# **EXTERNAL AGENCY AND STAKEHOLDER MEETING MINUTES**

**Date:** July 12, 2017      **Project Number:** PR-3130A  
**Location:** Conservation Halton – Committee Room 1      **Project: 1650-10586**      Regional Road 25 Municipal Class Environmental Assessment (MCEA) Study  
**Time:** 9:00 a.m. to 11:00 a.m.      **Author:** Paula Burnard, Stantec

### **Regional Road 25 Corridor Improvements – Steeles Ave. to 5 Side Road, Milton/Halton Hills PR-3130A CH File MPR 708**

# Key Areas of Focus

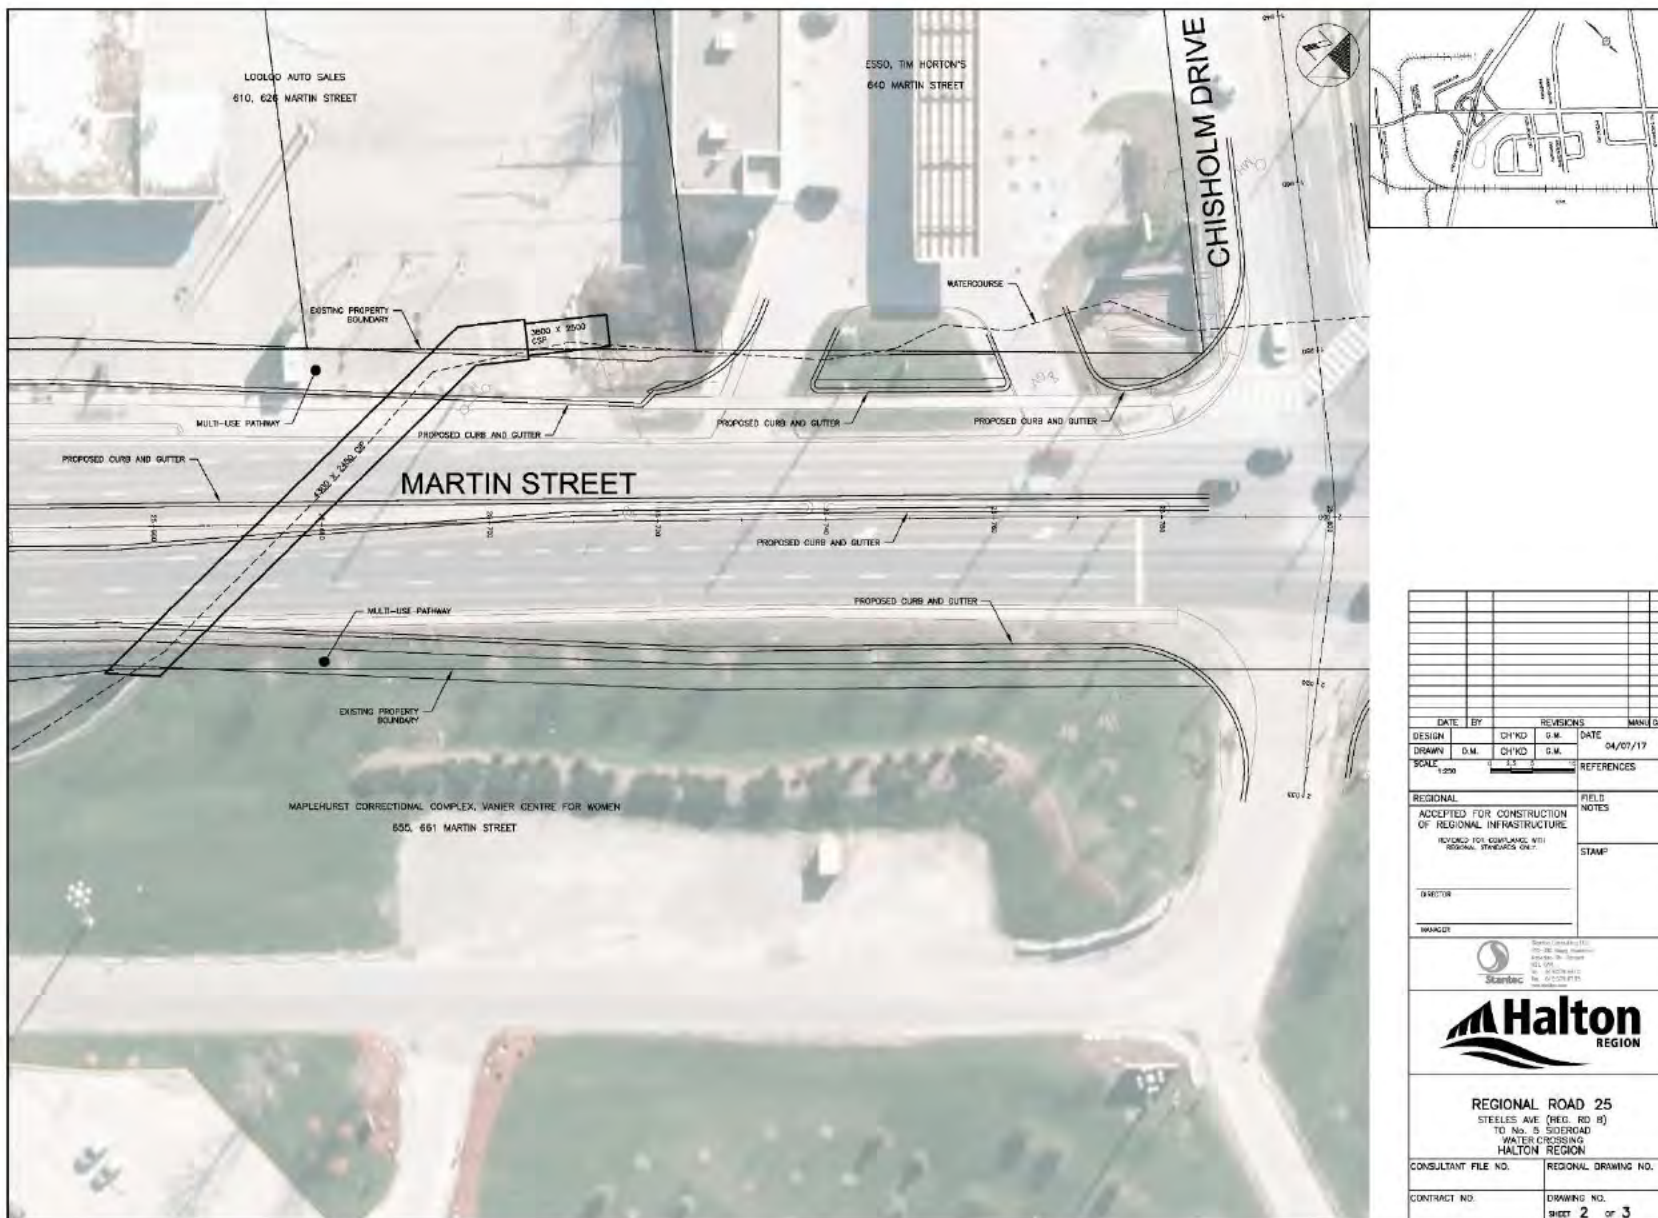
4.0	<b>Site Walk with CH</b>	
4.1	<p>Following the in-person meeting, a site walk was conducted, including each culvert location, with staff from CH, the Region and Stantec. See presentation (page 6), Key Areas of Focus map.</p> <p>Crossing #1 (C1) – North of Steeles Avenue</p> <ul style="list-style-type: none"> <li>- Redside Dace habitat</li> <li>- Monarch Butterfly habitat identified (milkweed) in corridor. The Monarch is designated as “endangered” under the federal <i>Species at Risk Act</i> and “special concern” under the <i>Endangered Species Act</i>. The species is under review and may be “up-listed” from “special concern” to “threatened” under the <i>Endangered Species Act</i>.</li> <li>- Remove abandoned ESC measures (filter sox, silt fencing) downstream (east side) of crossing</li> </ul> <p>CH requested the Region consider a metal wildlife passage “shelf”</p> <p>Crossing #2 (C2/C3)– C2 south of Chisholm Drive / C3 at Chisholm Drive (west side)</p> <ul style="list-style-type: none"> <li>- Redside Dace habitat</li> <li>- Downstream CN culvert is undersized, which increases risk of flooding at the Correctional facility. CH suggested that this could be an opportunity to address the issue with CN. Consider tying into existing infrastructure</li> </ul>

Item	Details	Action By
	<ul style="list-style-type: none"> <li>- Use higher retaining walls on the west side to avoid encroachment on the watercourse</li> <li>- Maximize the hydraulic capacity (don't pinch the low flow channel)</li> </ul> <p>Crossing #3 (C4) – North of Highway 401 (Tributary N-2B)</p> <ul style="list-style-type: none"> <li>- Redside Dace habitat present</li> <li>- Upstream – looking for low flow/rubble enhancement</li> <li>- Upstream Headwall and small wing walls may be required to accommodate road widening</li> <li>- Barn Swallow nest observed at downstream Headwall</li> <li>- Will require enhanced ESC due to Redside Dace</li> <li>- Treatment train concept will be incorporated</li> <li>- LIDs, tree pits, rain gardens to be considered in Reg. Rd. boulevards</li> <li>- Fish habitat assessment is required</li> </ul>

# Proposed OGS (at Culvert 1)

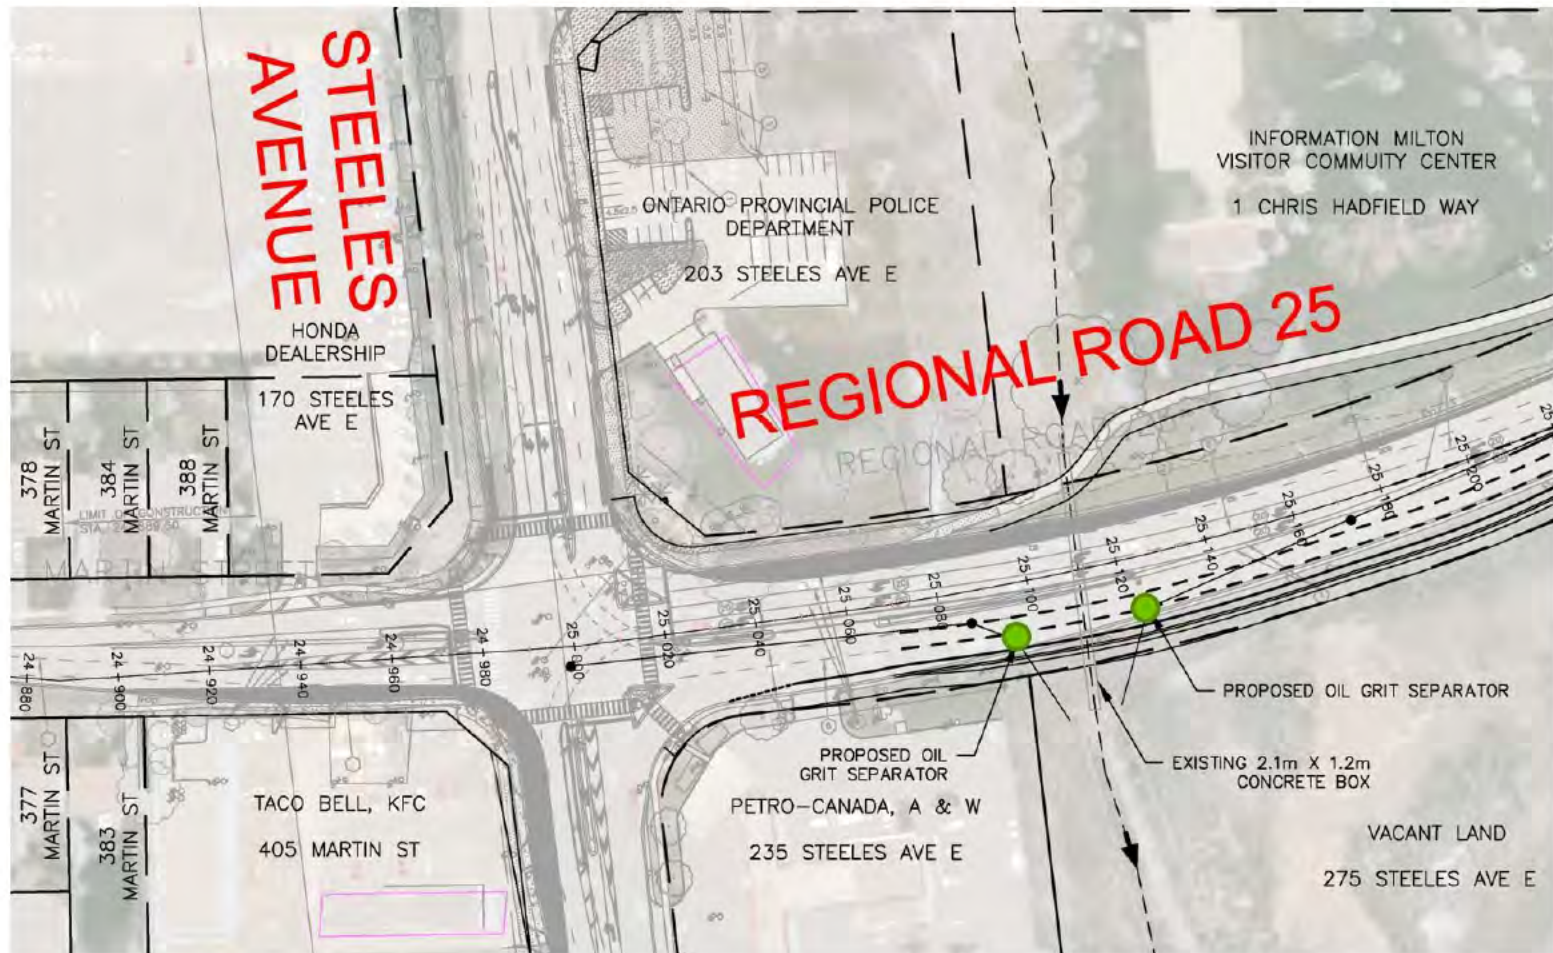
Comment	Response
7. Please note that staff are unable to support 80% TSS removal by two proposed OGS units (stand-alone units). We note that typically, to achieve 80% TSS removal, a treatment train approach is required which includes an OGS unit sized accordingly based on the entire drainage area (assumed as 50% TSS removal), <u>plus</u> an additional BMP (any type of LID). Please revise.	Quality control approach will be revised to add Jellyfish filters and/or treatment train including LID measures (e.g., catchbasin shields, infiltration trenches, underground chambers, enhanced swales).

8. Alternatively, units combining gravitational pre-treatment (sedimentation and floatation) and membrane filtration (for example Jellyfish® Filter units) can be considered as part of the design, which was verified to obtain 80% TSS removal subject to proper design and maintenance procedure.	Noted. Jellyfish filters and LID measures will be added as treatment train options to achieve “first flush” and TSS removal targets. To be confirmed during detailed design.

# Potential Low Impact Development (LID)

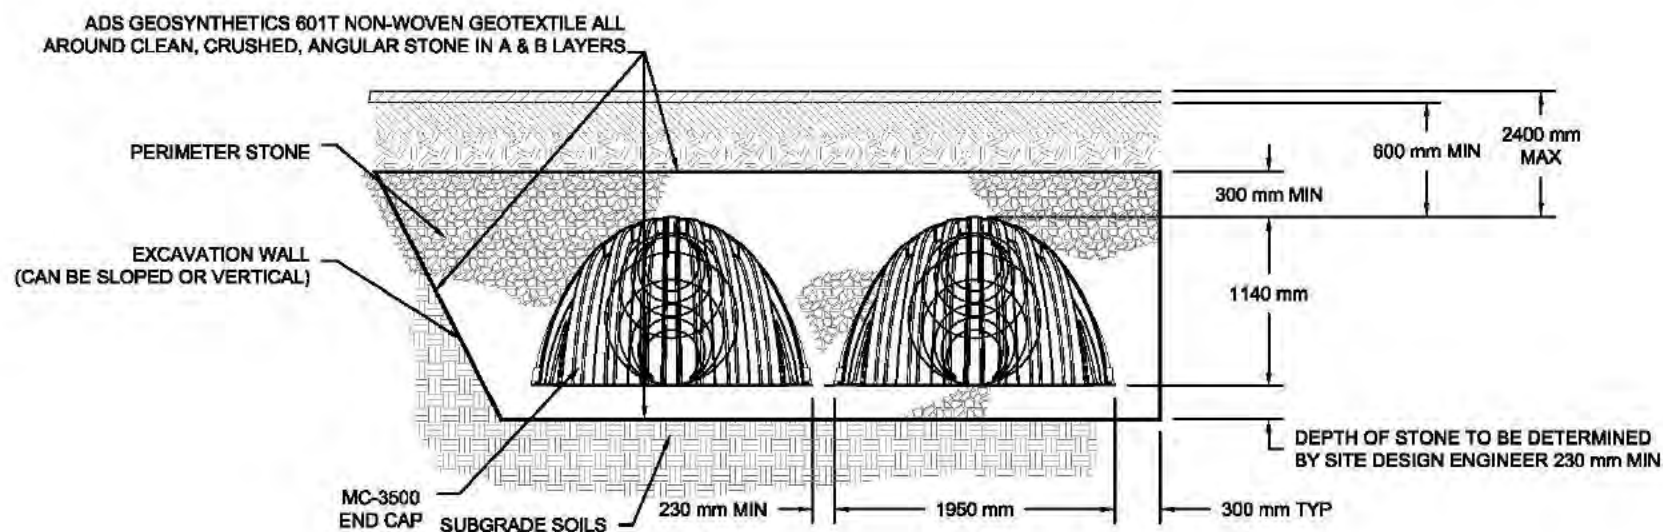
6. Bullet 3, notes that “Potential opportunities to implement infiltration measures/low impact developments (LIDs) should be identified and implemented wherever feasible and appropriate.” It is noted that the report does not provide any discussion to the potential opportunities to implement LID features. Staff recommend a section be added to the report.	A section will be added to the SWM report to discuss potential LID opportunities which are applicable for the project. Most likely options will include infiltration trenches and/or underground storage chambers with infiltration capabilities.
